SEWAGE DISPOSAL SYSTEM

DEPARTMENT OF HEALTH AND MENTAL HYGIENE

HOWARD COUNTY HEALTH DEPARTMENT

SUBDIVISION Clearview Estates LOT 45 ROAD 12031 Broad Meadow Lane

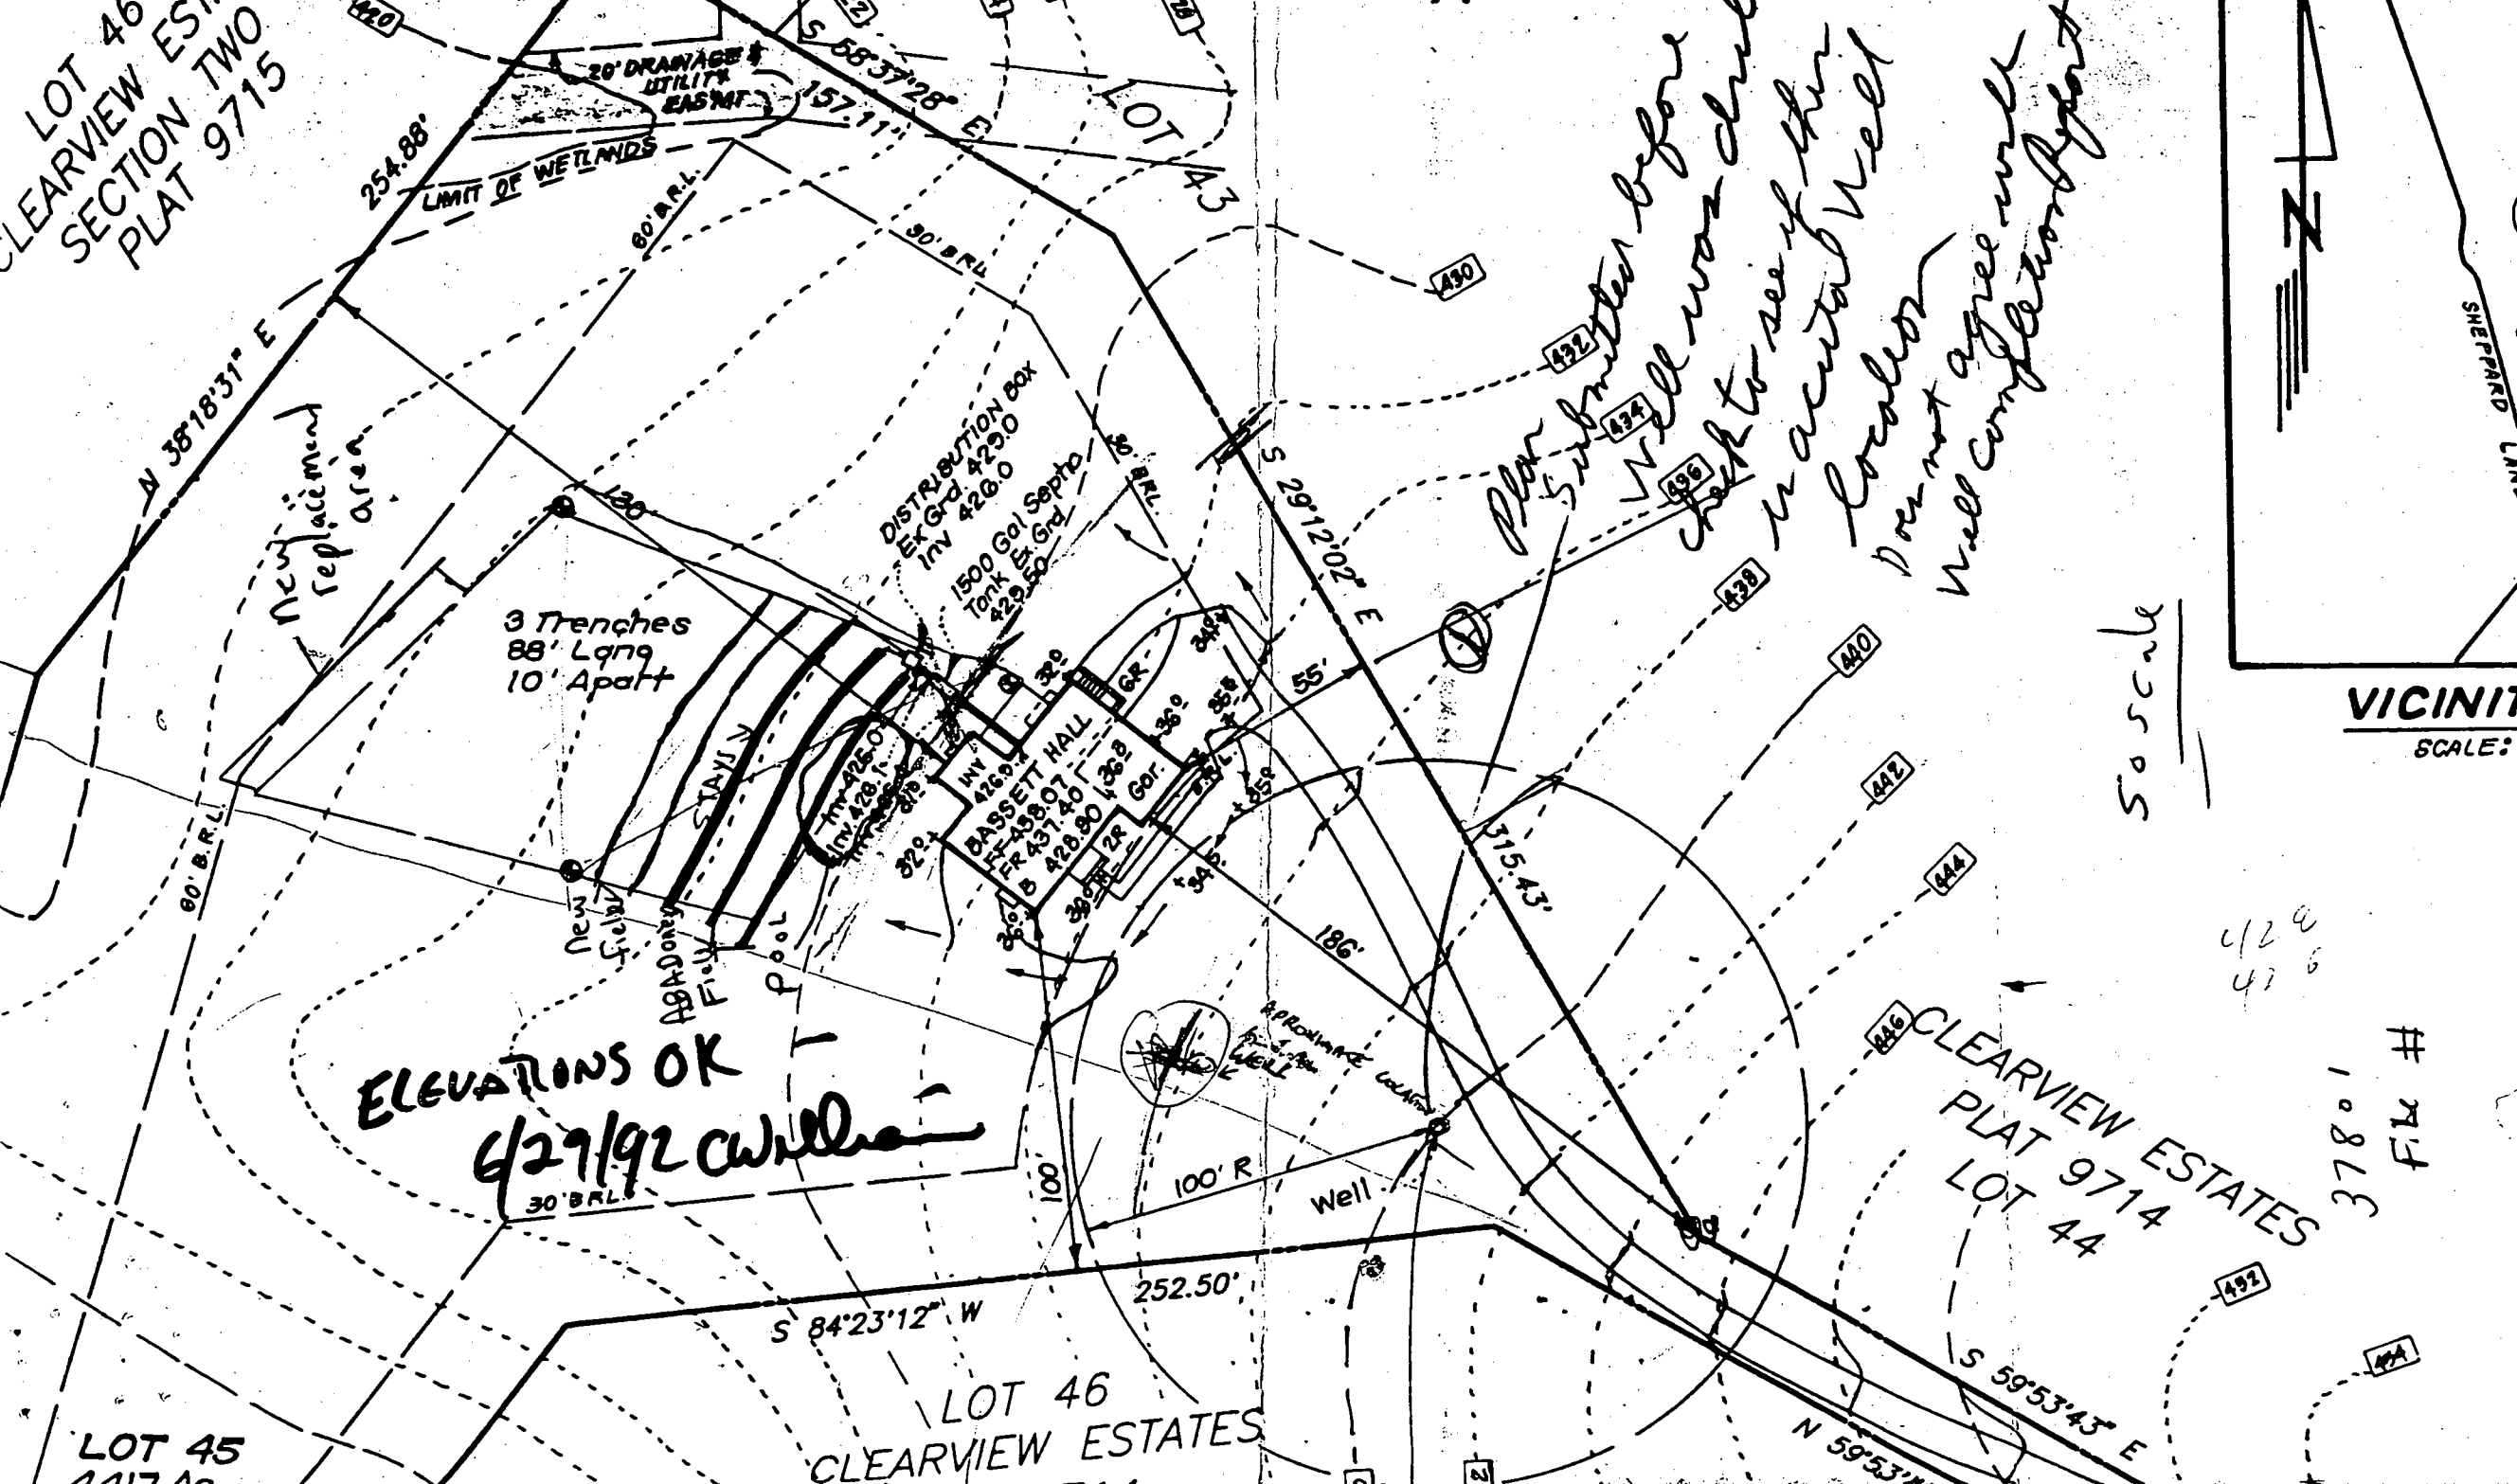
Plan submitted before well was drilled in actual location. Do not agree with well completion report.

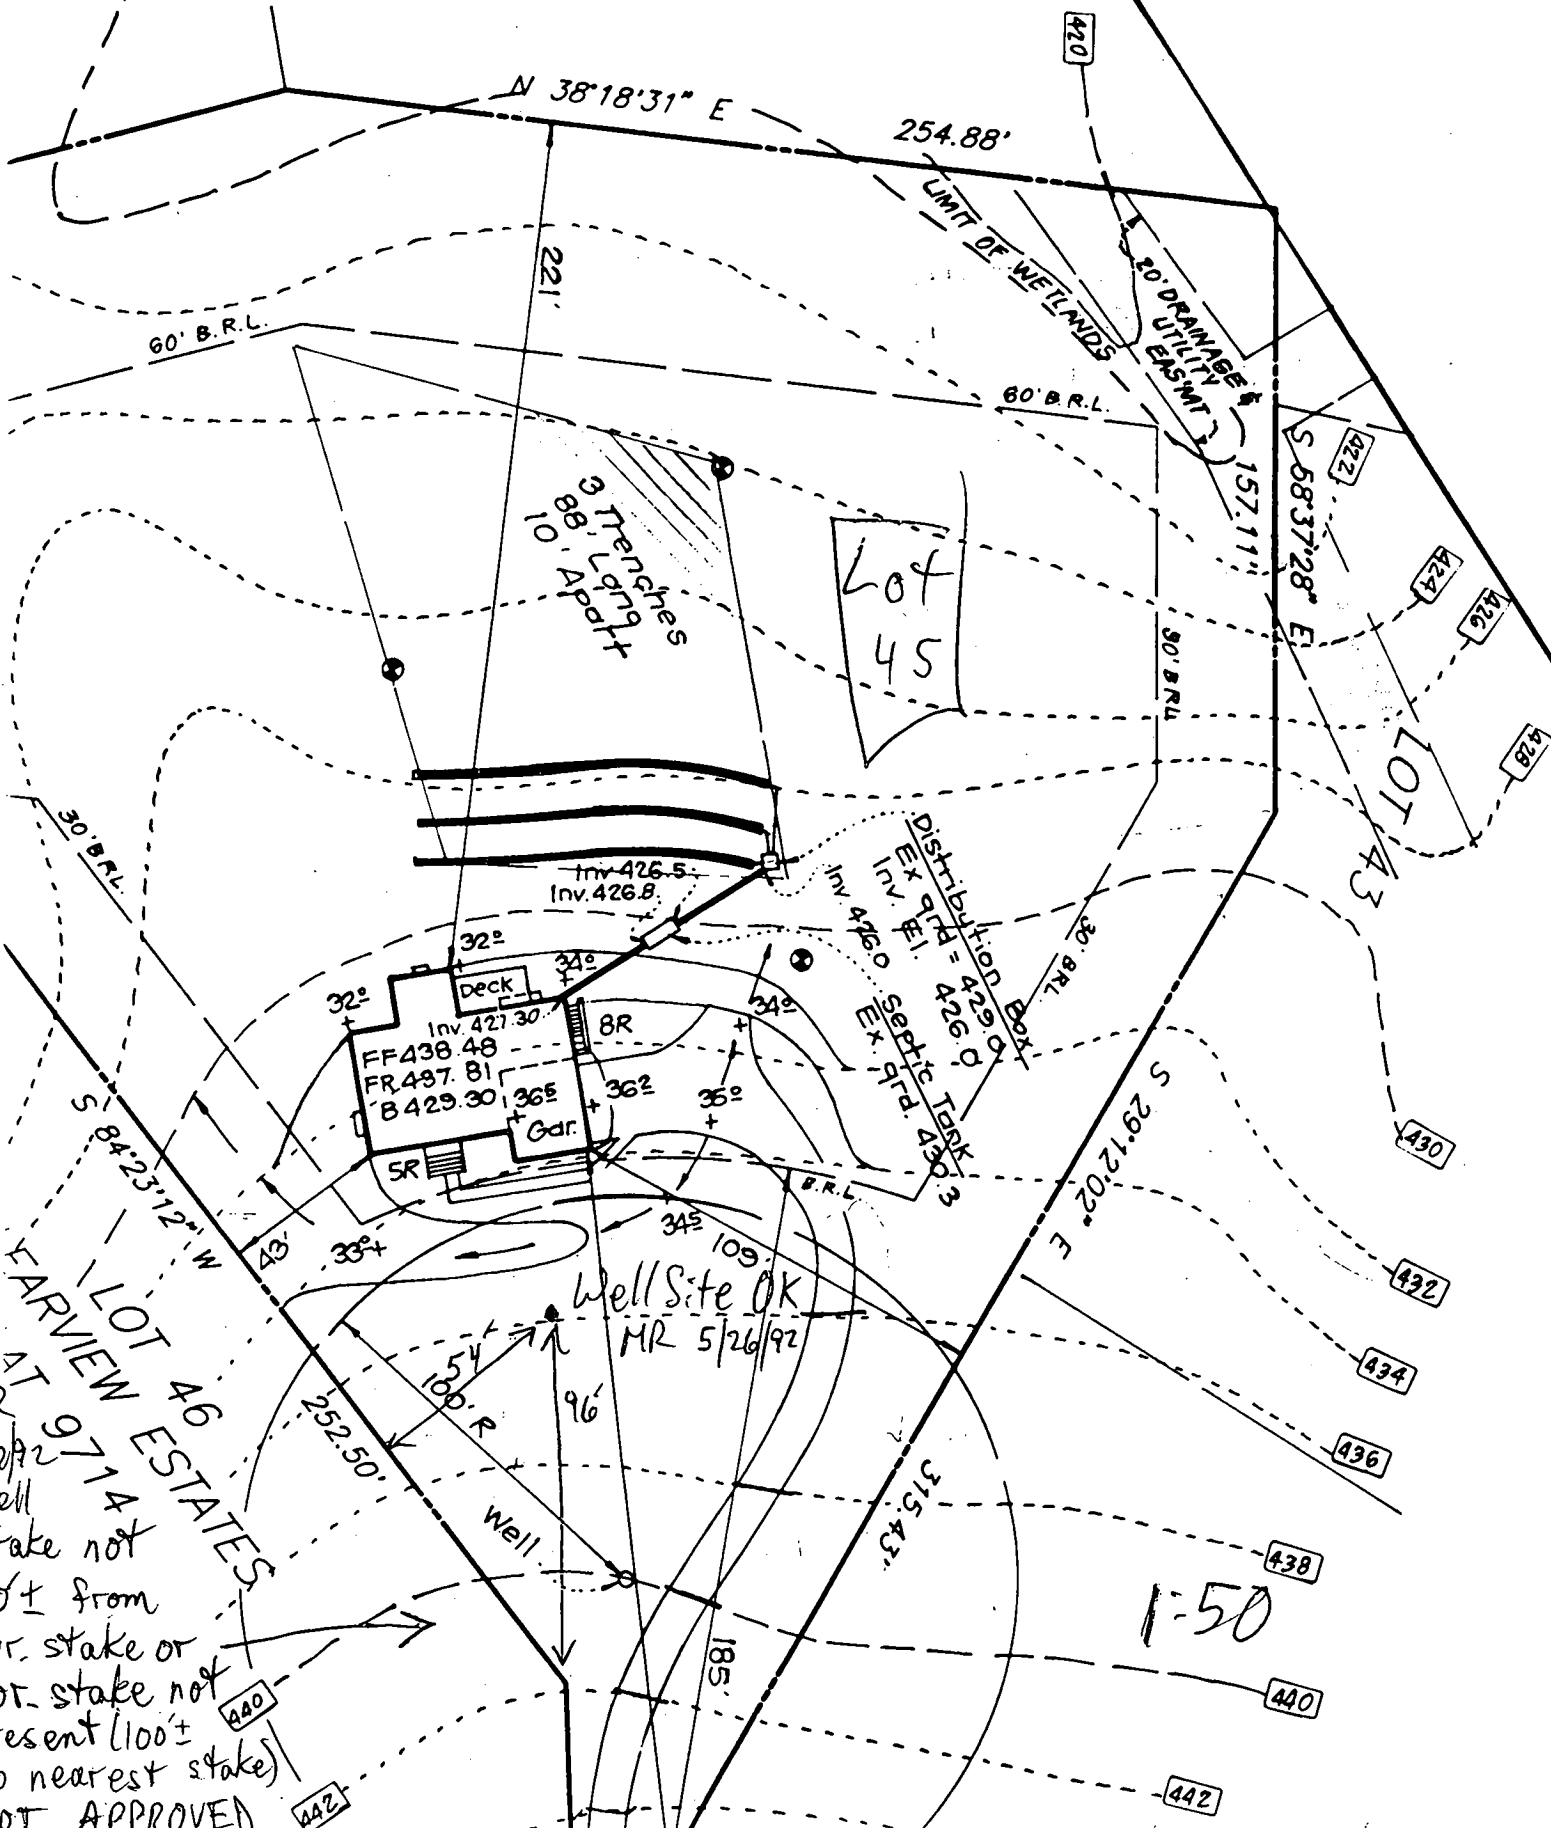
MR 5/22/92
 well stake not 30'± from cor. stake or cor. stake not present (100'± to nearest stake)
 NOT APPROVED

Well Site OK
 MR 5/26/92

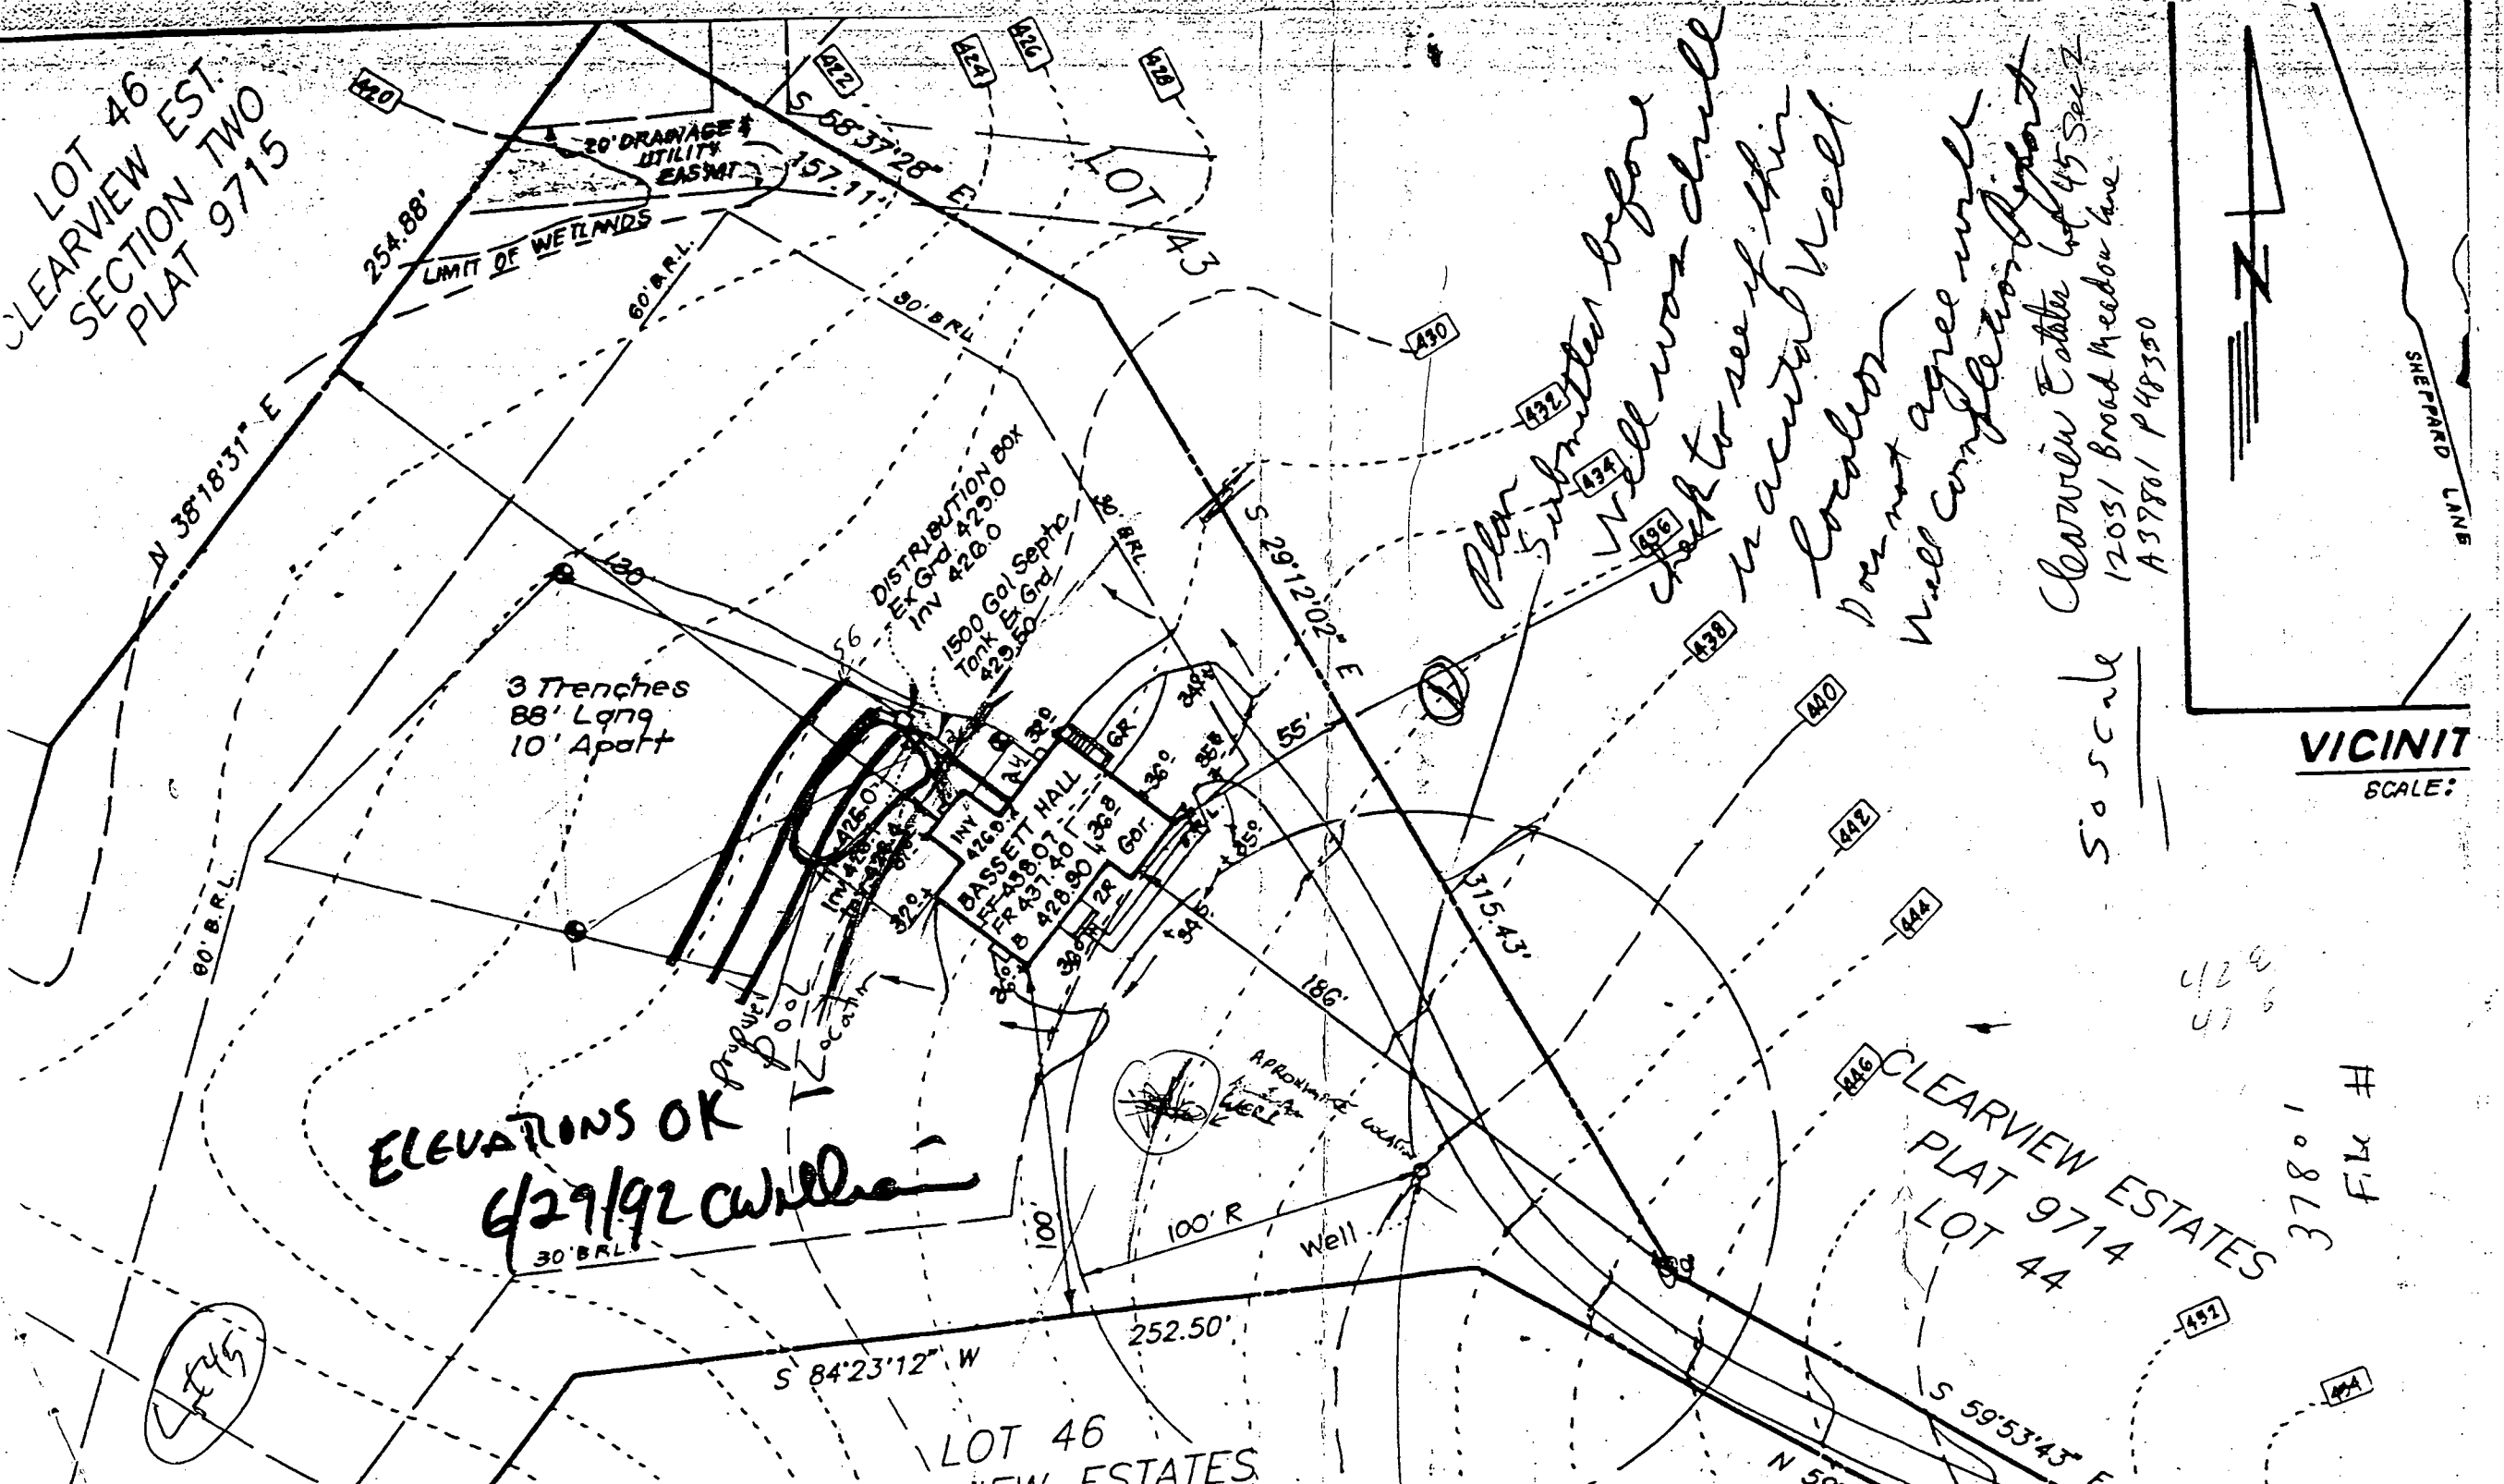
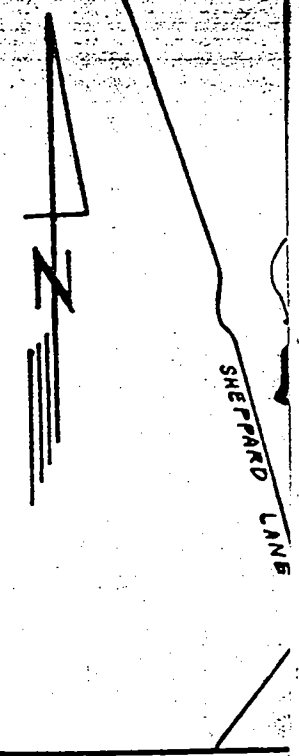
Plan submitted before well was drilled to see if this is actual well location. Do not agree with well completion report.
